City of Rohnert Park
Development Services

SUBJECT: CITY OF ROHNERT PARK
ROHNERT PARK STREET SMART PROJECT
PROJECT NO. 2013-02;

ADDENDUM NO. 3

DRAWING NO. C102

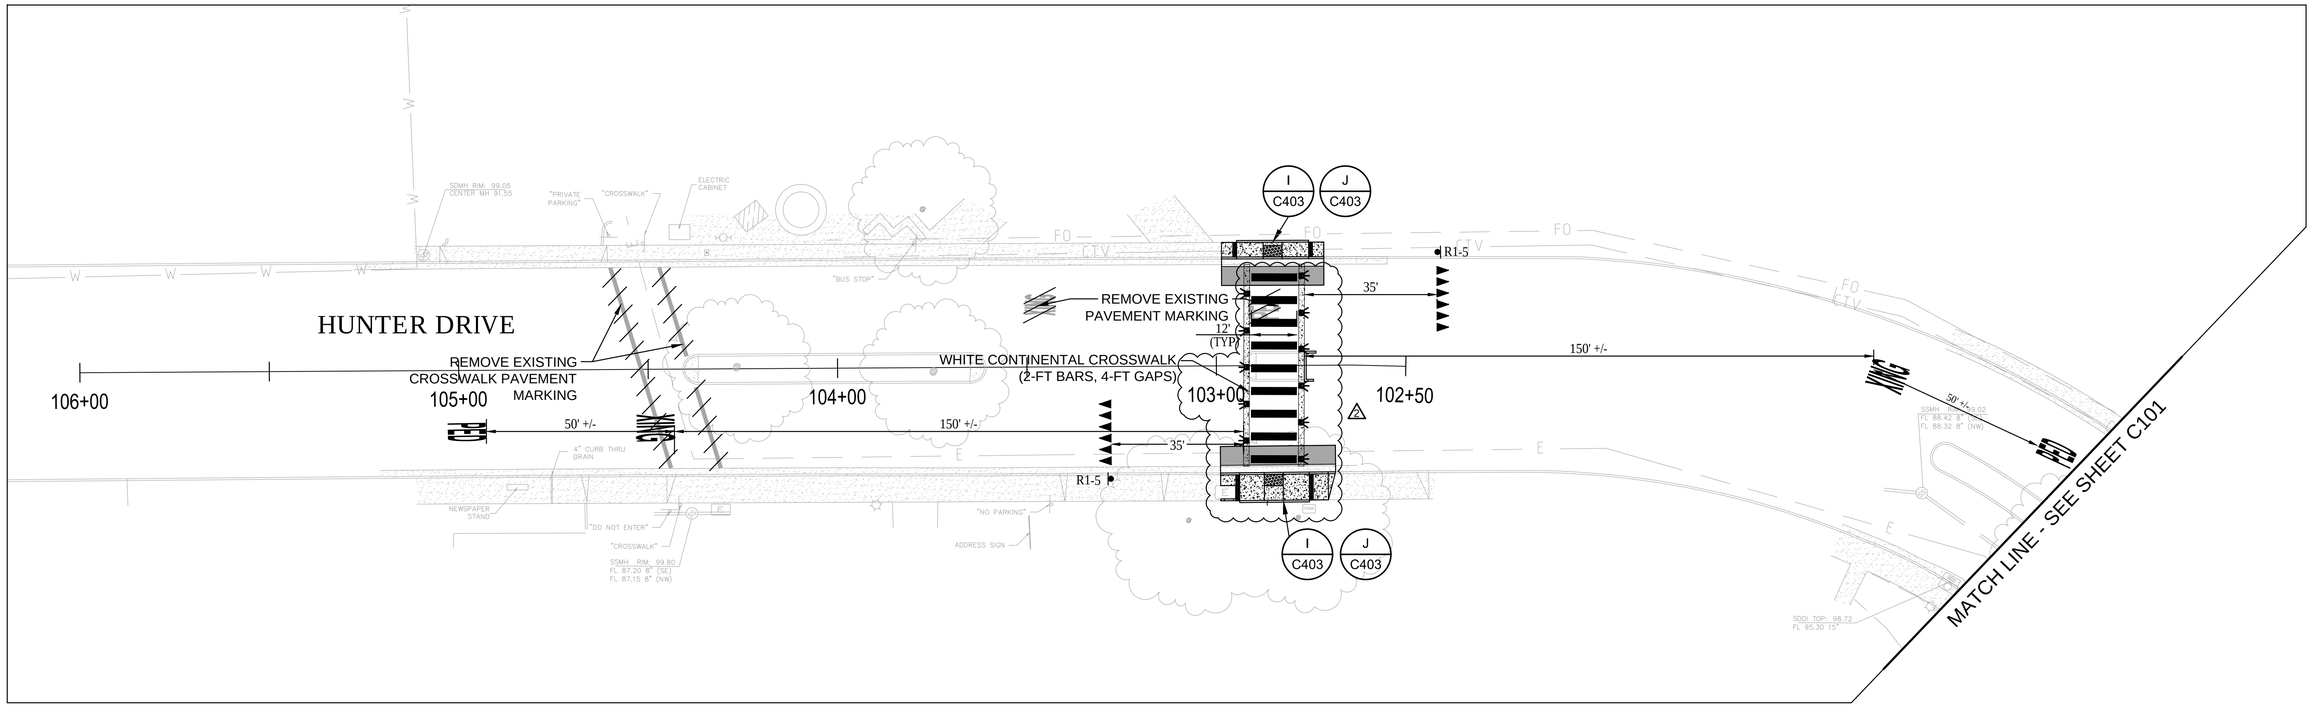
MARK	DATE	DESCRIPTION	BY	APPR.
2	12/07/2016	IN-GROUND LIGHTING MODIFICATIONS

DRAWING NO. TS101

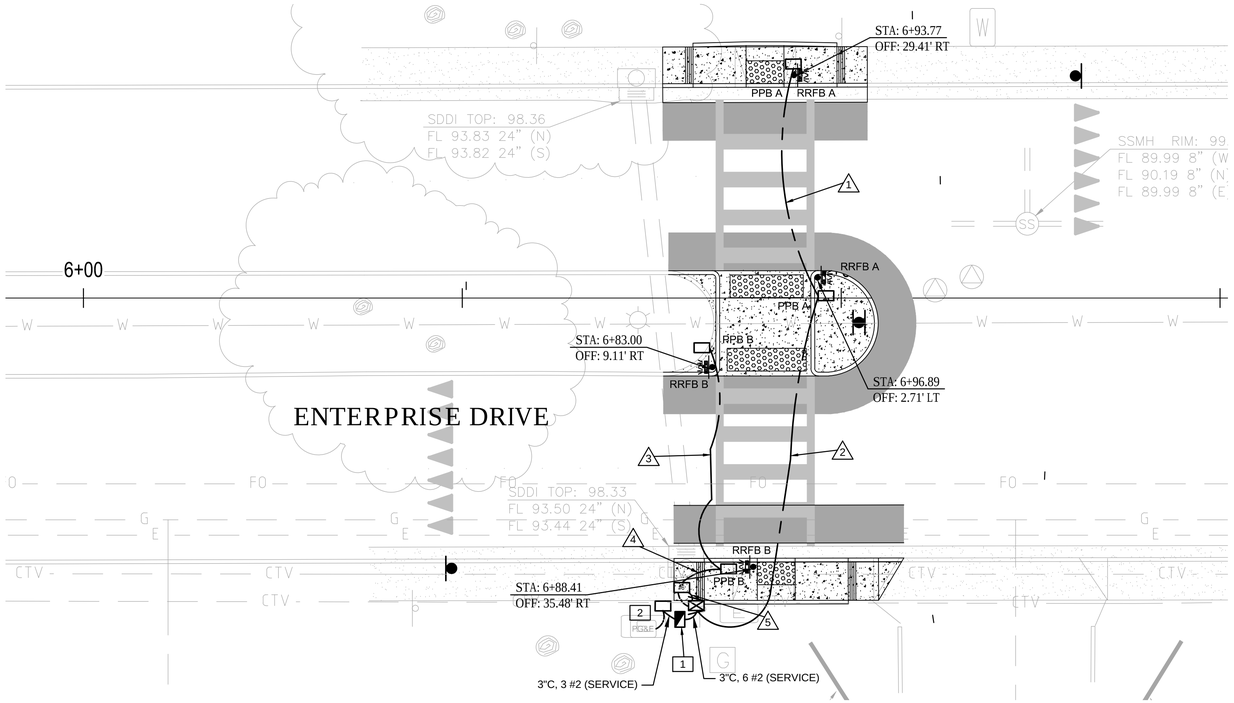
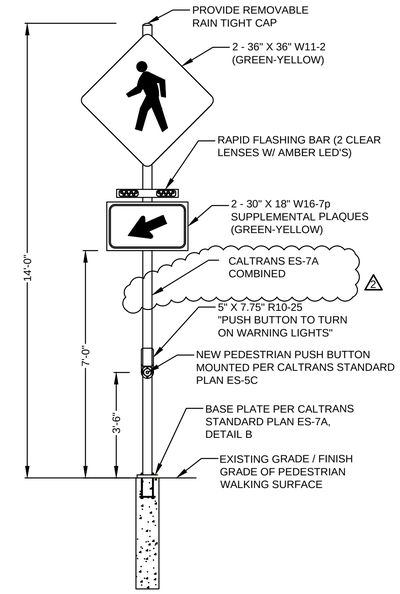
MARK	DATE	DESCRIPTION	BY	APPR.
2	12/07/2016	RRFB MODIFICATIONS

DRAWING NO. TS103

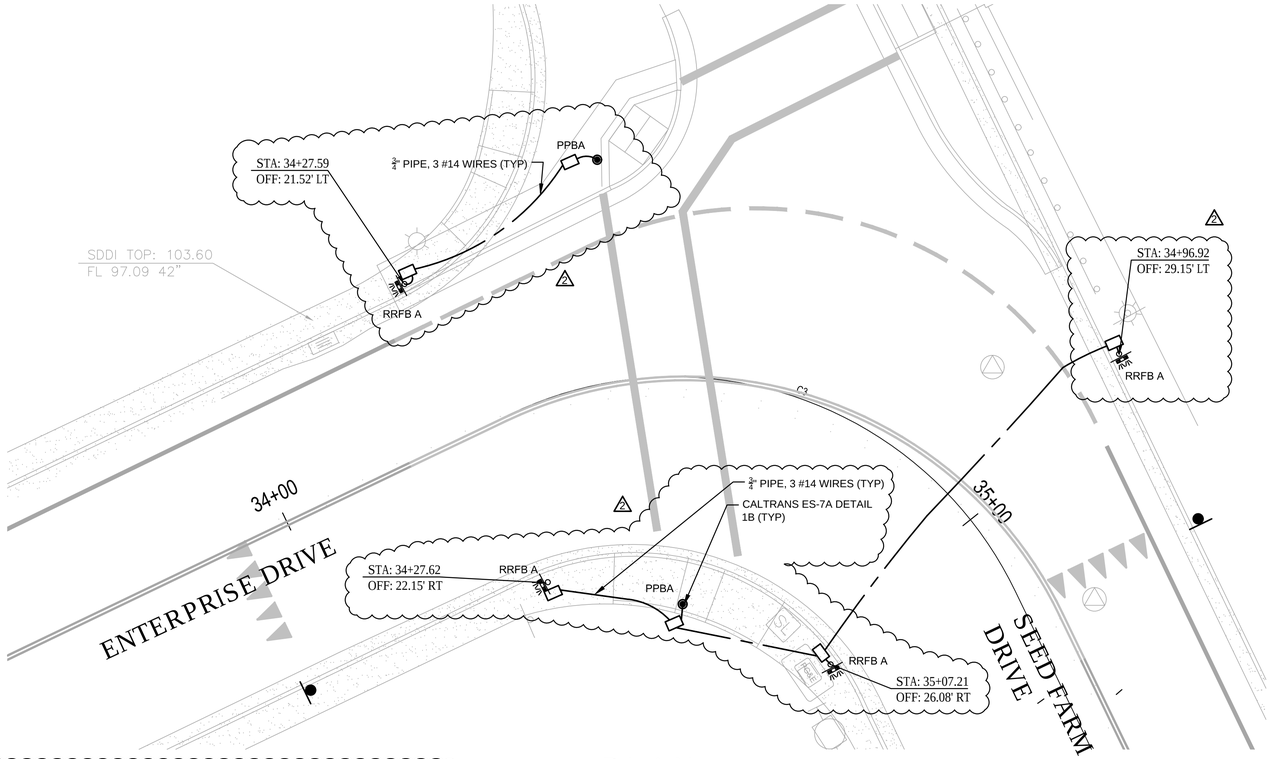
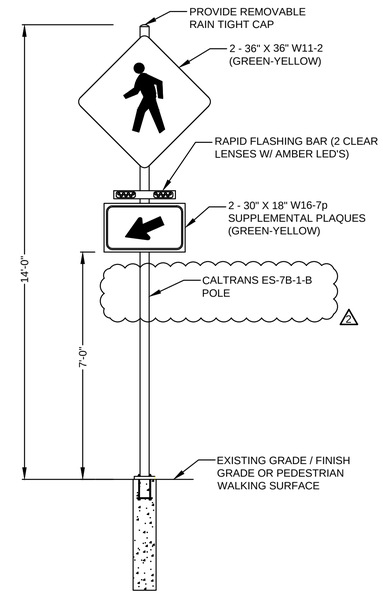
MARK	DATE	DESCRIPTION	BY	APPR.
2	12/07/2016	RRFB MODIFICATIONS

DRAWING NO. TS104

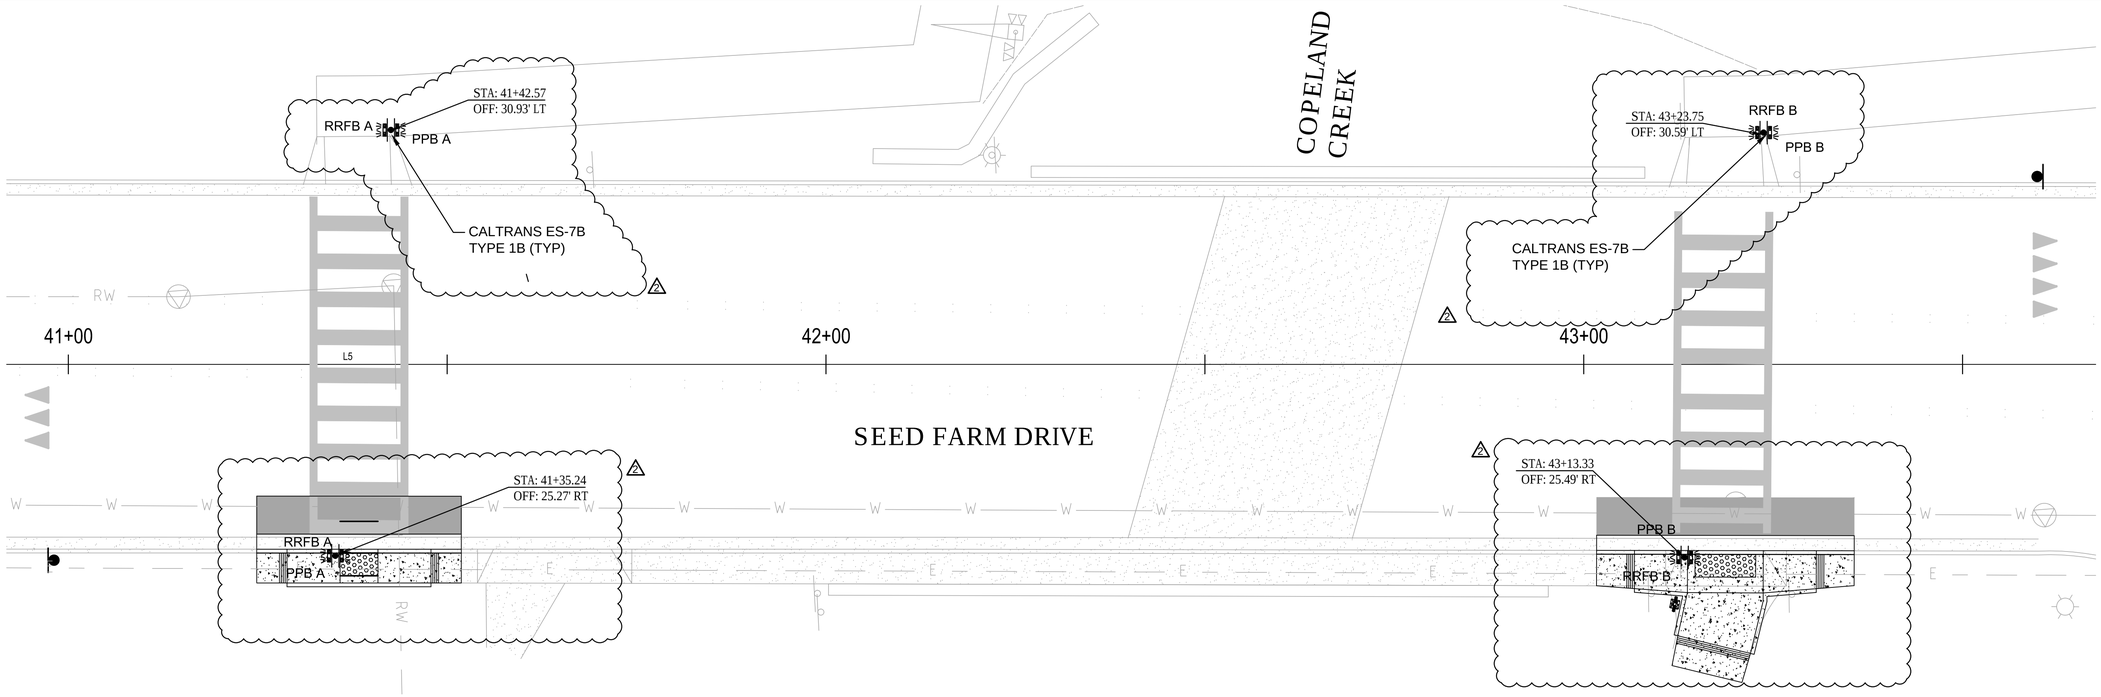
MARK	DATE	DESCRIPTION	BY	APPR.
2	12/07/2016	RRFB MODIFICATIONS
